MAJOR ALTERATIONS + ADDITIONS TO
THE STEVENSON LIBRARY (SSD 8922)

S4.55 Modification Application

S4.55-2 MODIFICATION APPLICATION

1 Proposed Ground Floor Plan RL 54.99
Scale: 1:200

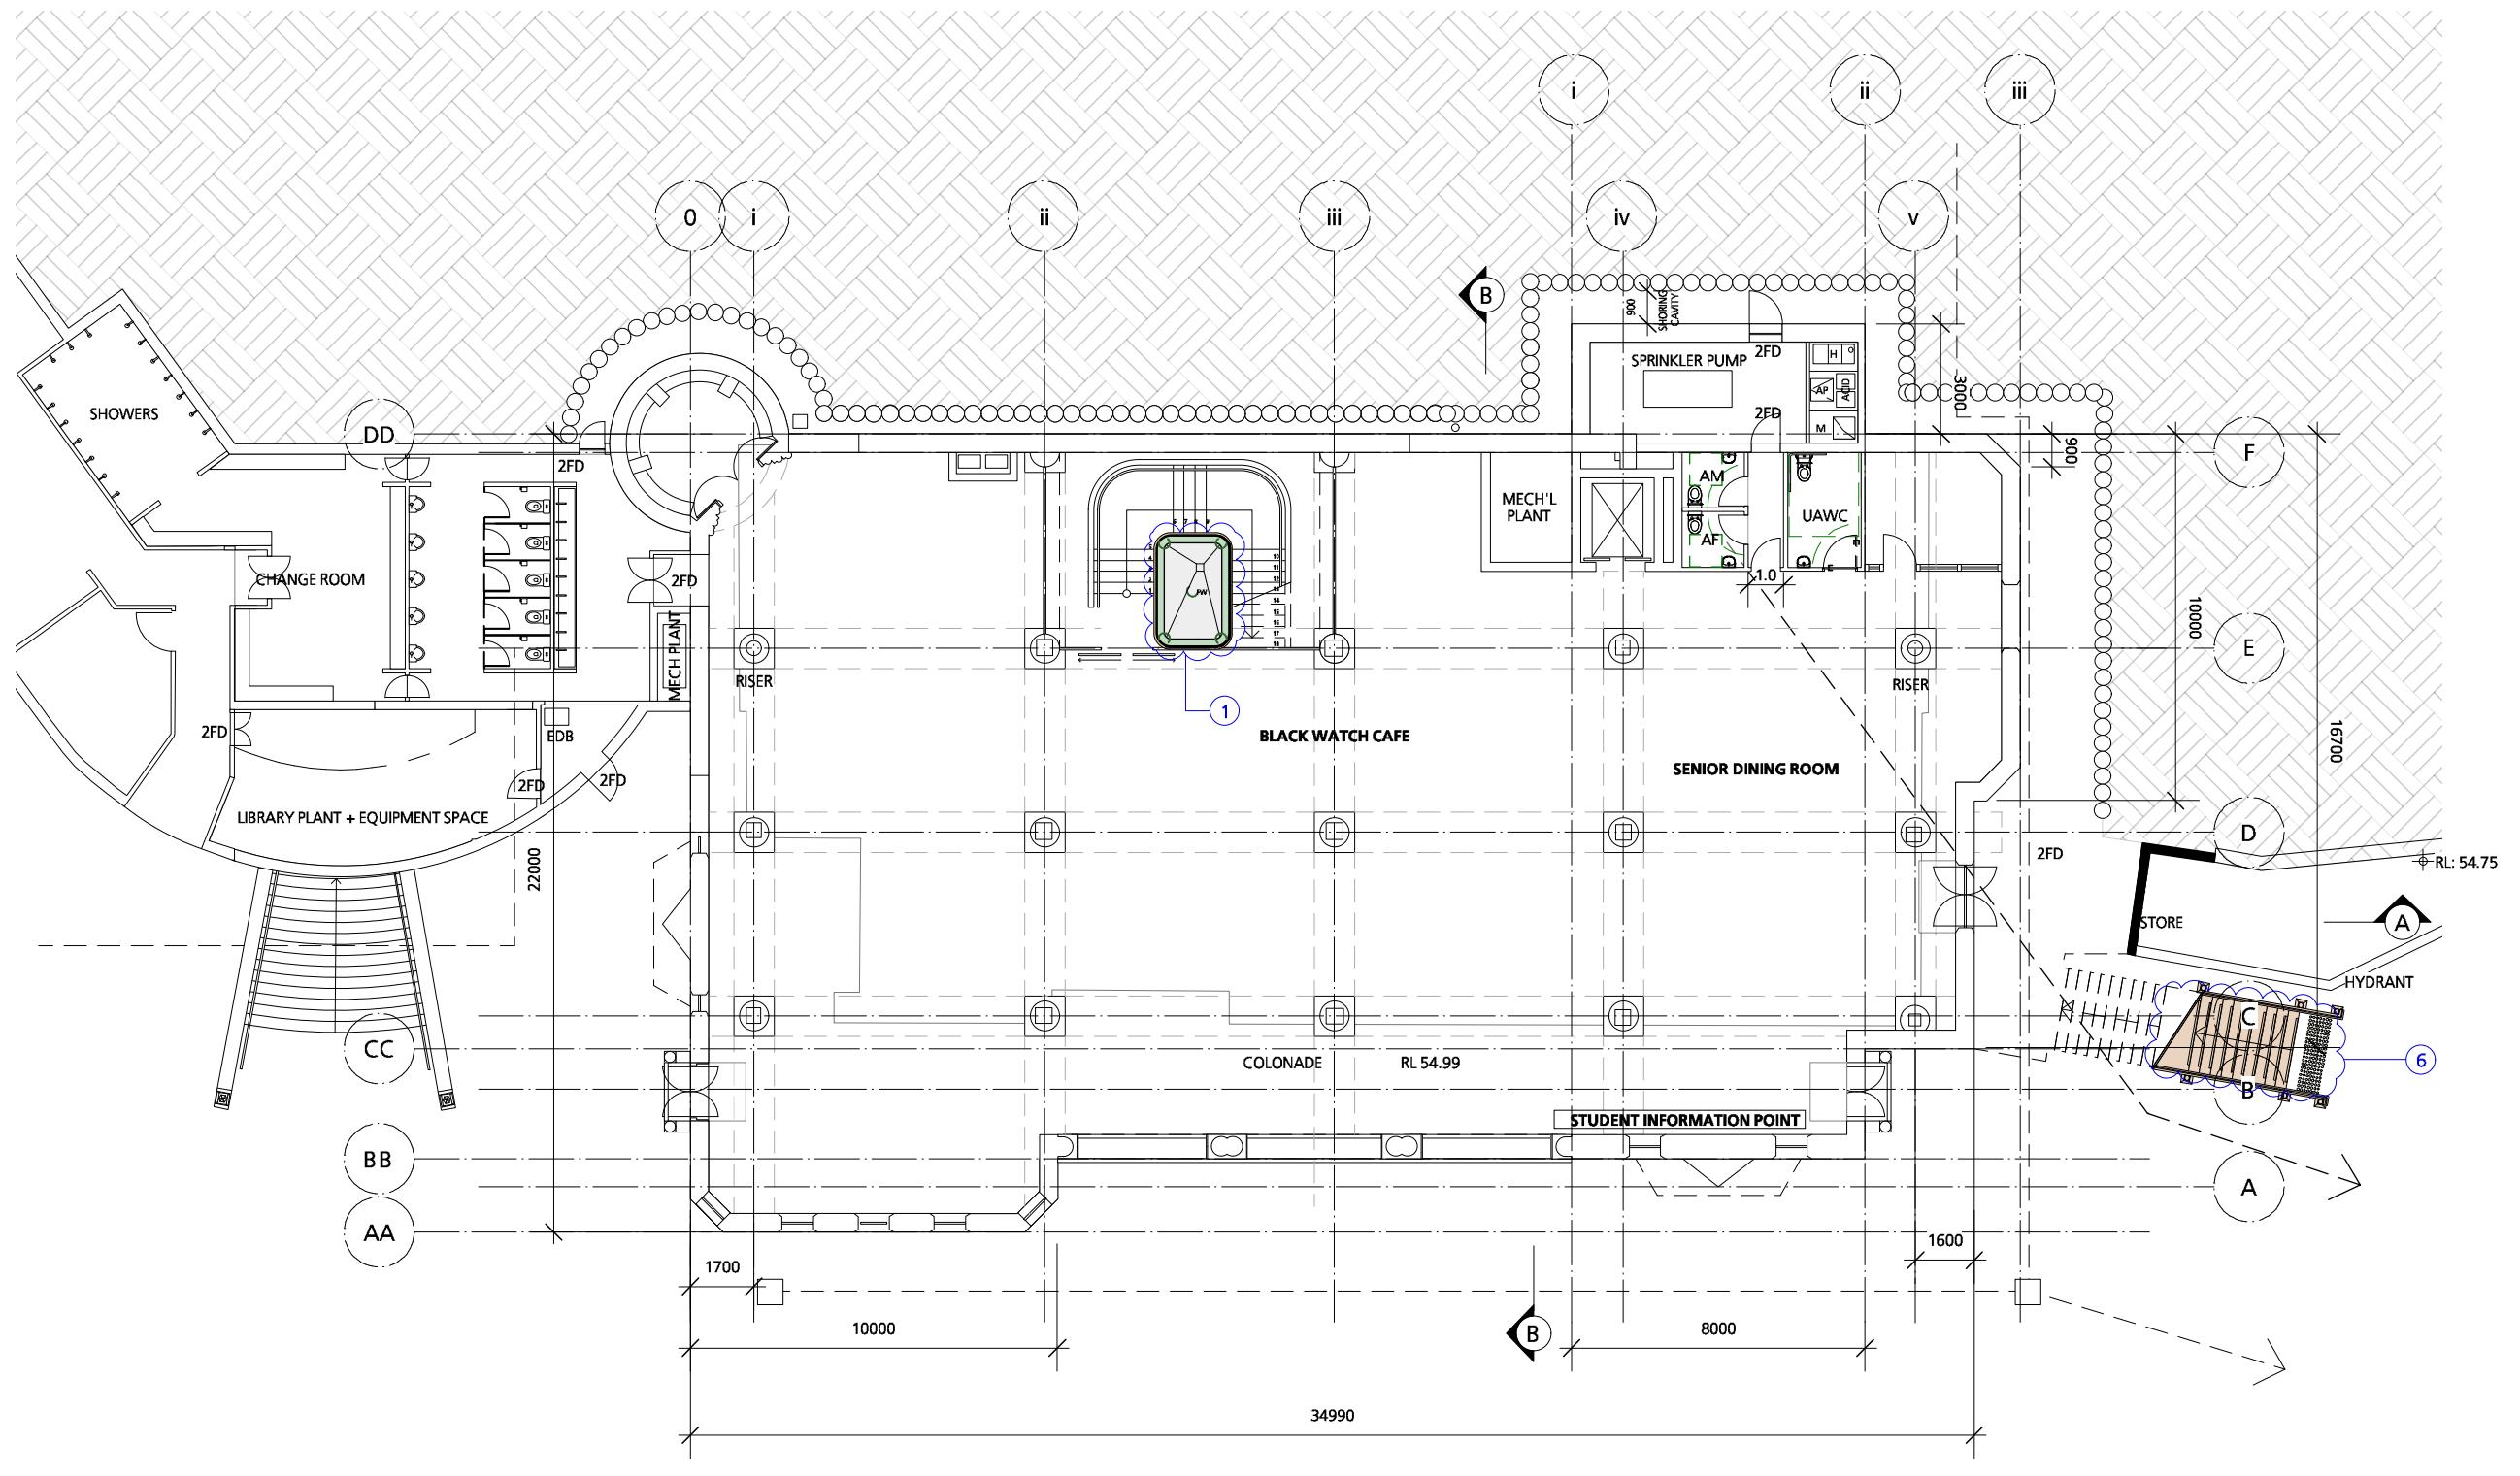
1. Fresh air riser added
2. Crow step added to gable
3. First floor colonade added to quadrangle
4. Fenestration to verandah amended
5. Verandah roof replaced
6. External northern stair amended
7. Excavate undercroft

1 Proposed Third Floor Plan RL 65.275
Scale: 1:200

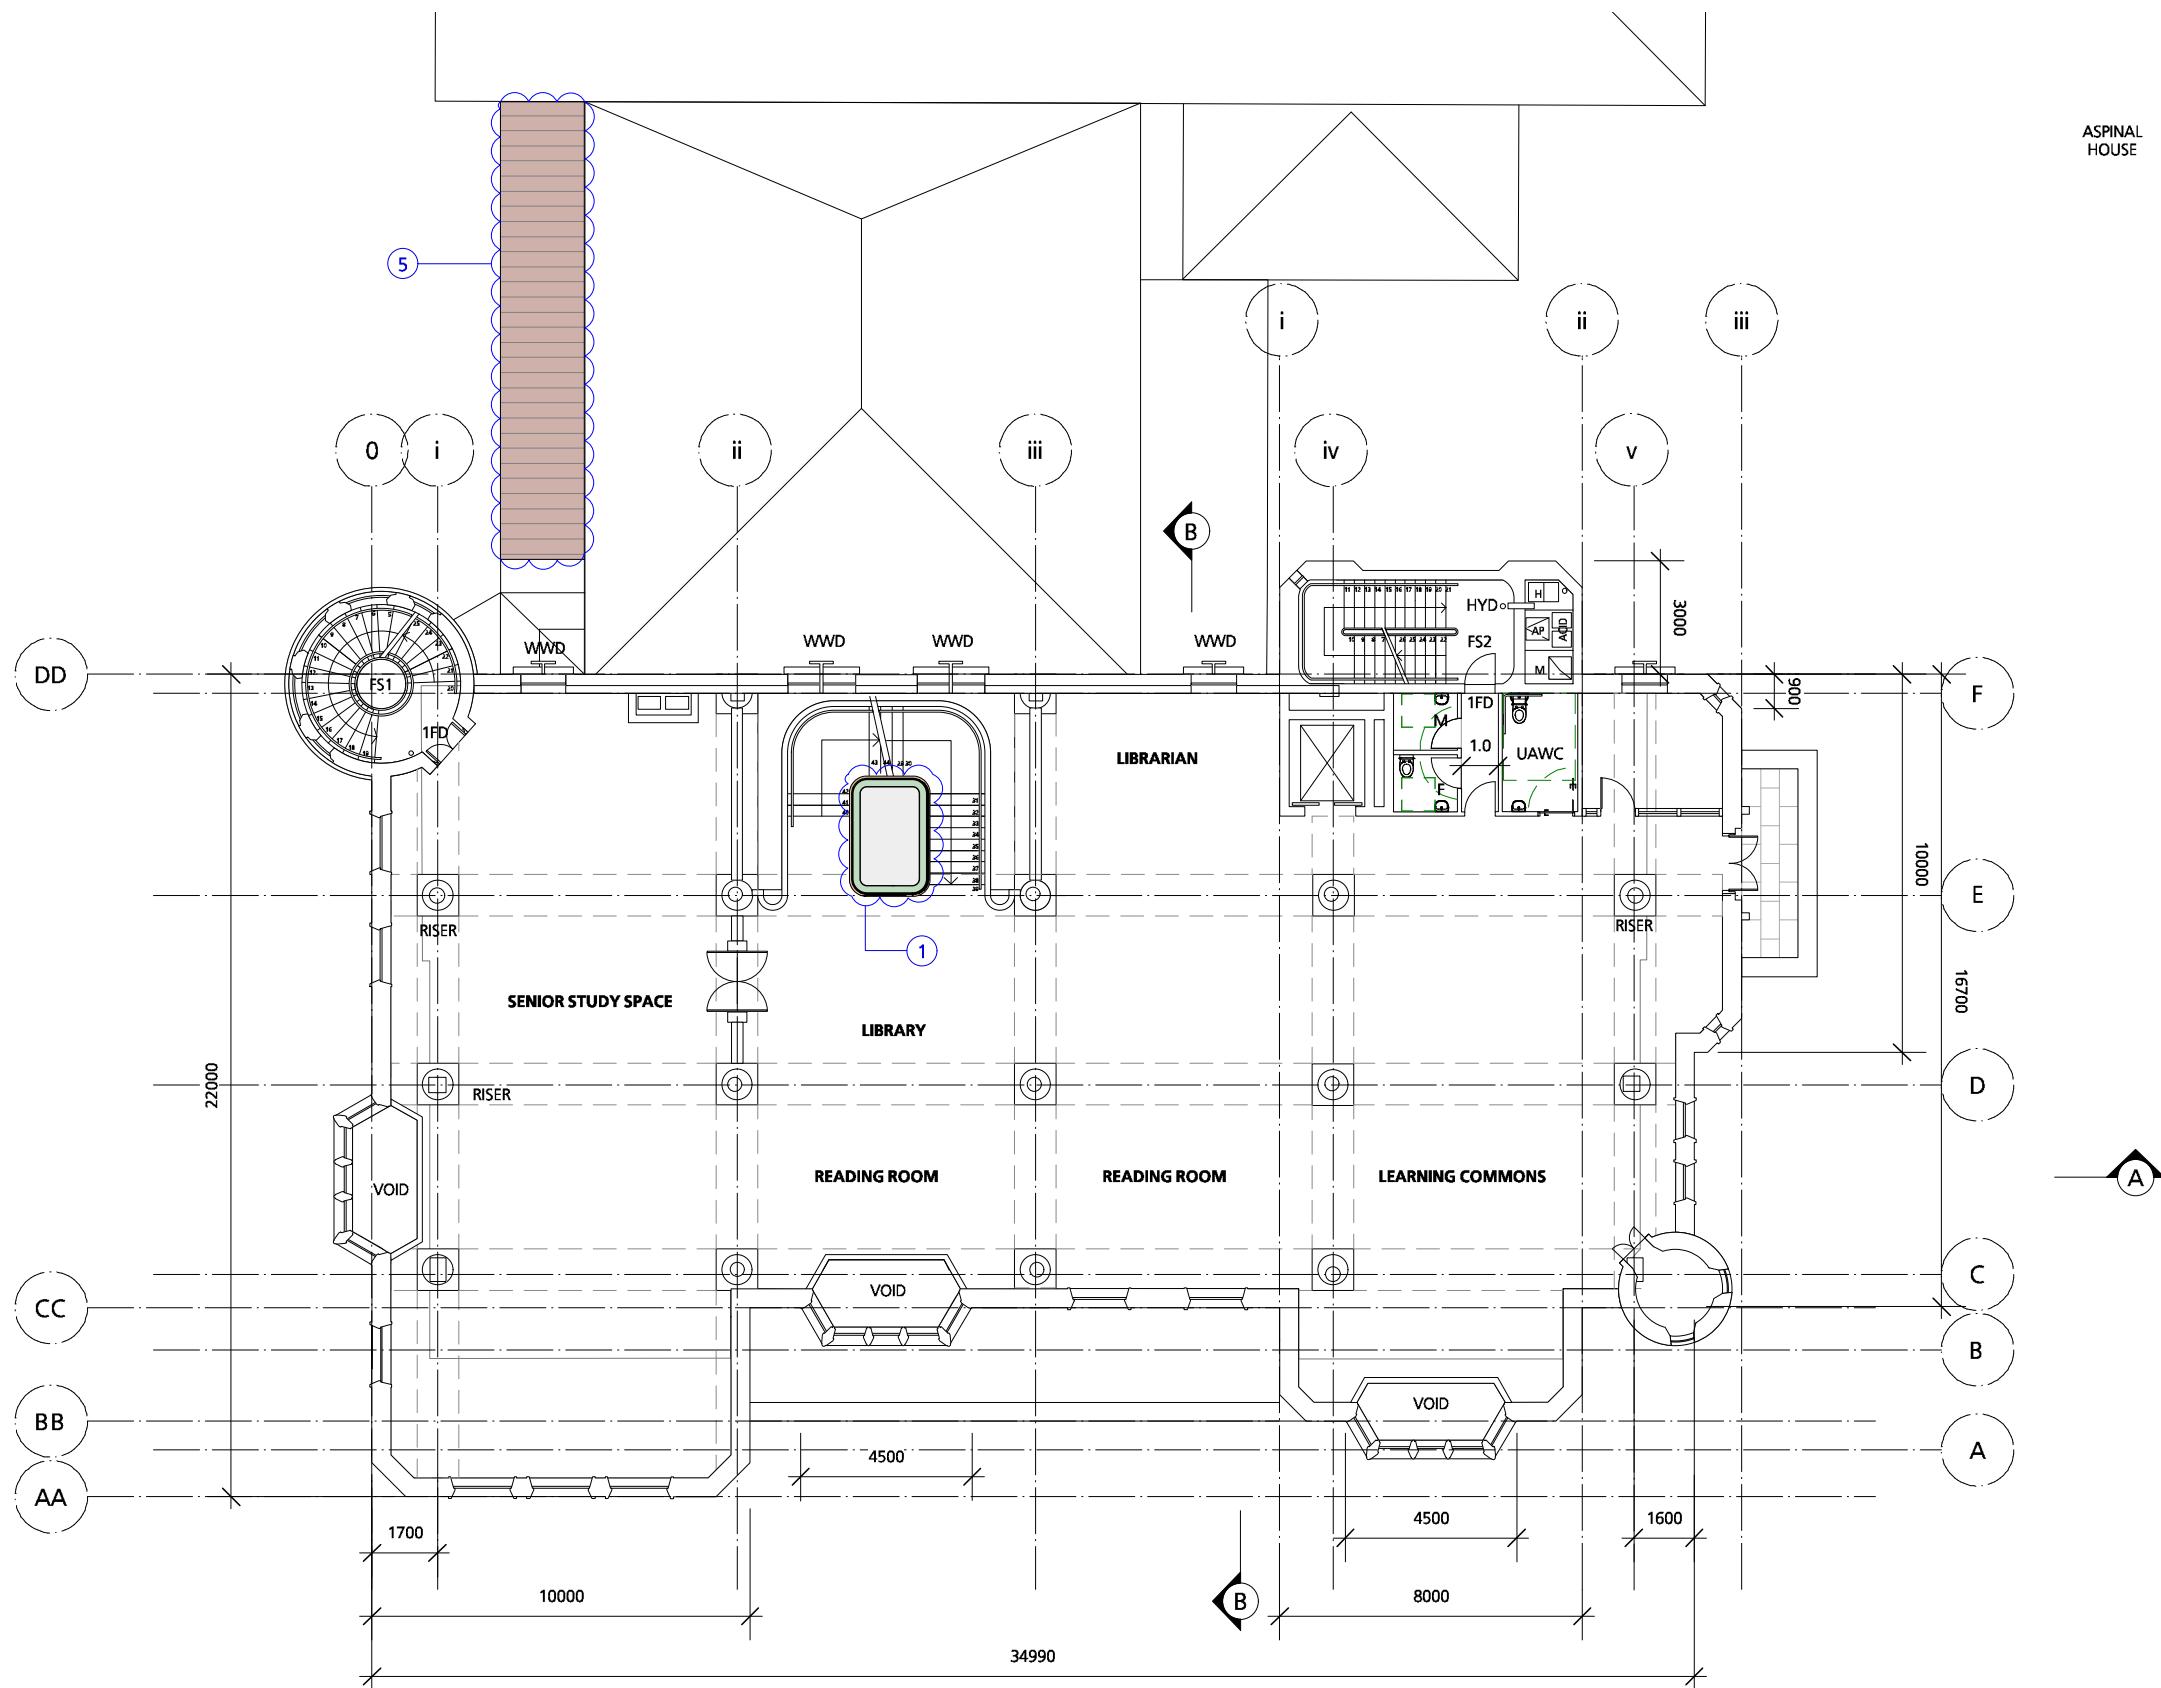
1. Fresh air riser added
2. Crow step added to gable
3. First floor colonade added to quadrangle
4. Fenestration to verandah amended
5. Verandah roof replaced
6. External northern stair amended
7. Excavate undercroft

1 Proposed Fourth Floor Plan RL 67.95
Scale: 1:200

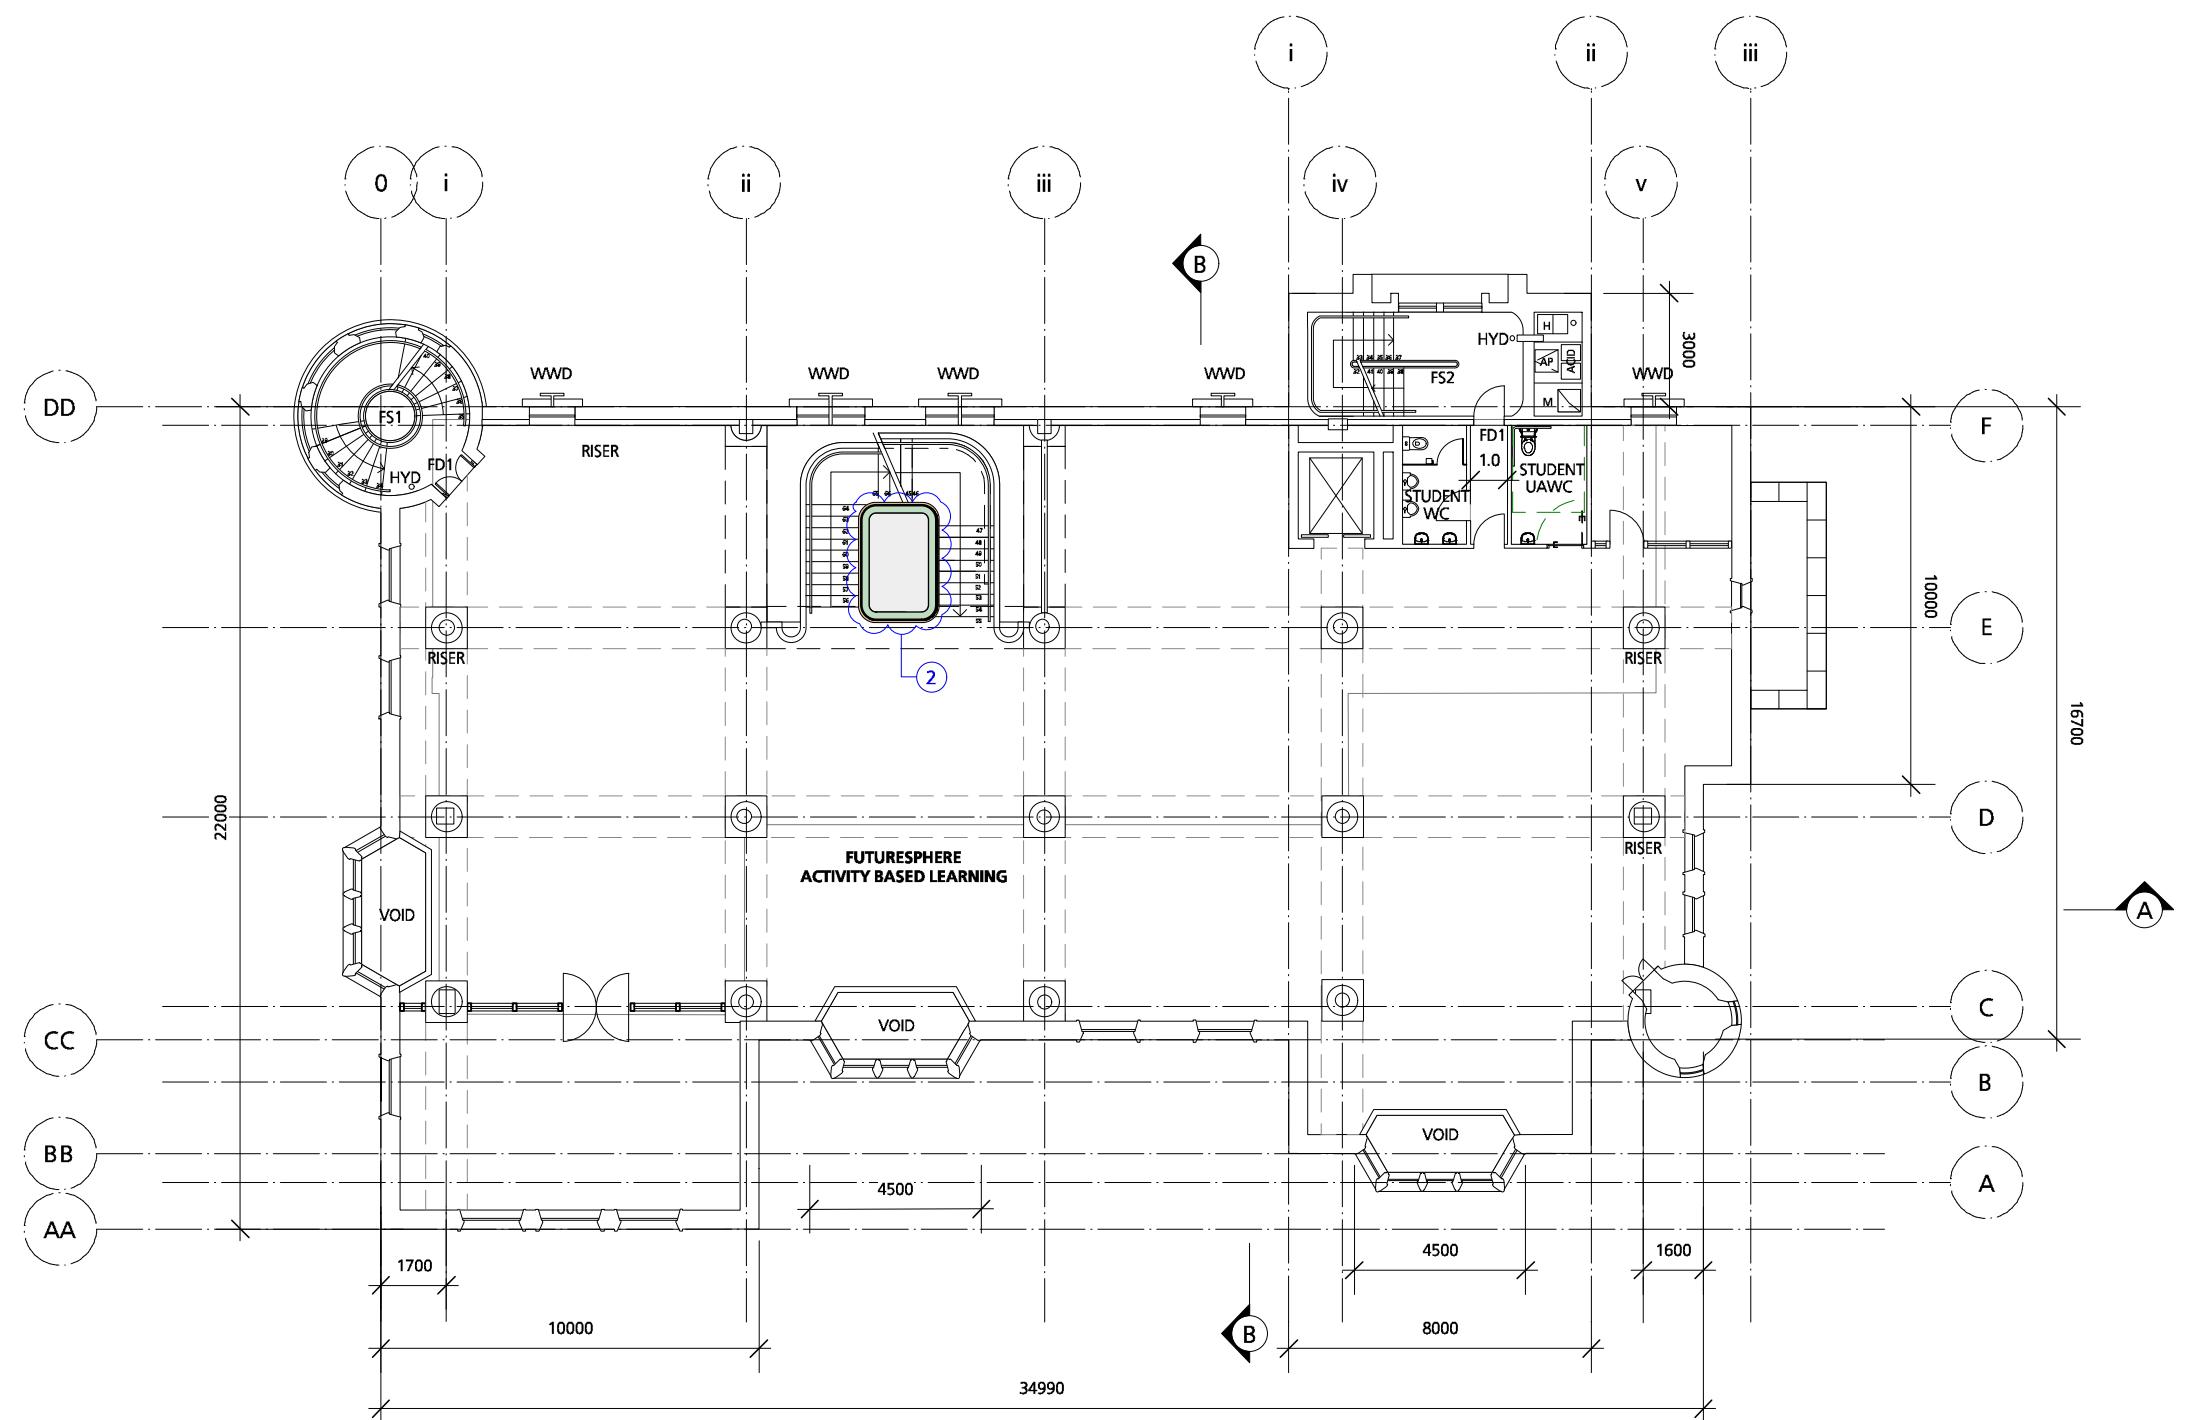
1. Fresh air riser added
2. Crow step added to gable
3. First floor colonade added to quadrangle
4. Fenestration to verandah amended
5. Verandah roof replaced
6. External northern stair amended
7. Excavate undercroft
